Kanturk Electoral Area Local Area Plan Public Consultation Draft

Supplementary Managers Report

28 March 2011

Managers Recommended Amendment Ref.KK.01.10.03

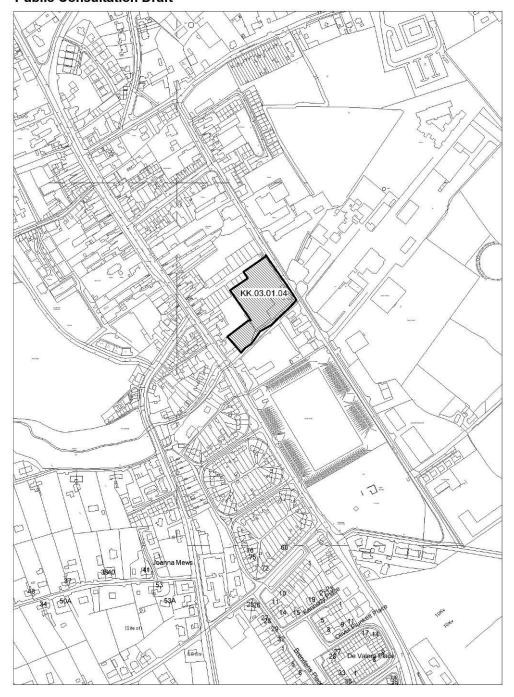
Ref.	Draft Change Title	2010 DLAP Page No.
	Section One : Introduction	
KK.01.10.02	Revise wording of amendment to say	13
	"Amend GB1-2 designation at Millstreet to exclude areas located within the Natura 2000 site (Blackwater River c SAC)	
	This amendment refers to a map change only	
	See map attached.	
KK.01.10.03	Amend GB1-2 designation in Kanturk to exclude areas located within the Natura 2000 site (Blackwater River c SAC)	17
	This specific amendment refers to a map change only.	
	See map attached.	
	Charleville	
KK 03.01.04	Amend wording of this amendment to include reference to the need for a Flood Risk Assessment (new text in bold)	29
	Return area zoned as T-01 (north of ESB site) in the 2005 LAP to Town Centre uses as part of T-01 of the Draft Plan. Amend wording of T-01 objective as follows:	
	T-01 Town Centre Uses. The Flood Risk Assessment has identified parts of the centre are at risk of flooding. Any development proposals in this area will normally be accompanied by a flood risk assessment that complies with Chapter 5 of the Ministerial Guidelines "The Planning System and Flood Risk Management" as described in objectives FD 1-4, 1-5 and 1-6 in Section 1 of this Plan.

Managers Recommended Amendment Ref.KK.03.03.09

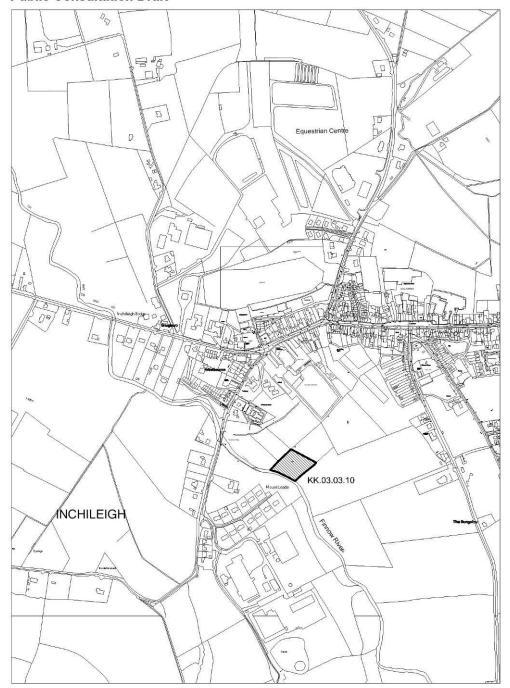
This amendment refers to a map and text change.	
	Millstreet	
KK.03.03.09	Amend wording of this amendment to include reference to the need for a Flood Risk Assessment (new text in bold)	42
	Following revised approach to flood management it is considered that lands previously designated as R-06 (2005 LAP) shall be reinstated as R-05 with the following wording.	
	R-05 Medium density residential development subject to satisfactory connection to the public sewer. The Flood Risk Assessment has identified parts of this site

as being at risk of flooding. Any development proposals on this site will normally be accompanied by a flood risk assessment that complies with Chapter 5 of the Ministerial Guidelines "The Planning System and Flood Risk Management" as described in objectives FD 1-4, 1-5 and 1-6 in Section 1 of this Plan. This amendment refers to a map and text change.	
KK.03.03.10	New map for change KK.03.03.10 attached – omitted from the Managers Report See map attached	43
KK03.03.11	Amend wording of this amendment to include reference to the need for a Flood Risk Assessment (new text in bold) Following revised approach to flood management it is considered that lands previously designated as R-08 (2005 LAP) shall be reinstated and now designated as R-06 with the following wording. R-06 Medium density residential development. A sewer pumping station shall be provided on site. The Flood Risk Assessment has identified parts of this site as being at risk of flooding. Any development proposals on this site will normally	42

Managers Recommended Amendment Ref.KK.03.15.03

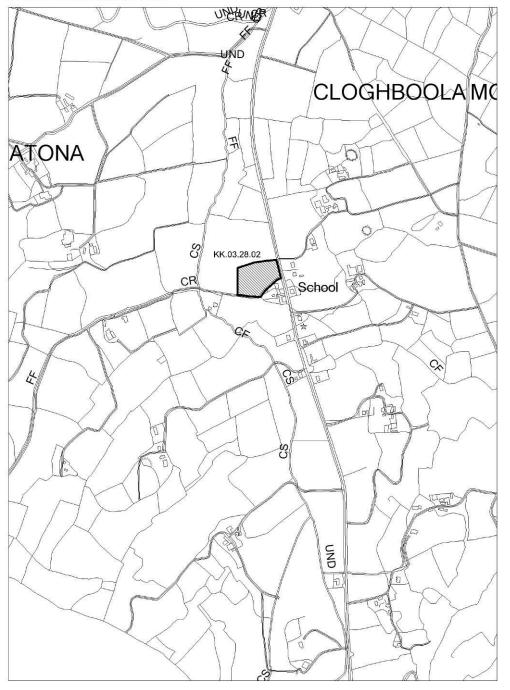
KK.03.15.03	Following revised approach to flood management it is considered that the entirety of lands previously designated as I-02 (2005 LAP) should be reinstated as B-02. B-02 Business Estate Development. The Flood Risk Assessment has identified parts of this site as being at risk of flooding. Any development proposals on this site will normally be accompanied by a flood risk assessment that complies with Chapter 5 of the Ministerial Guidelines "The Planning System and Flood Risk Management" as described in objectives FD 1-4, 1-5 and 1-6 in Section 1 of this Plan. This amendment refers to a map and text change. Cullen Amend development boundary of Cullen to omit lands within the Blackwater	92
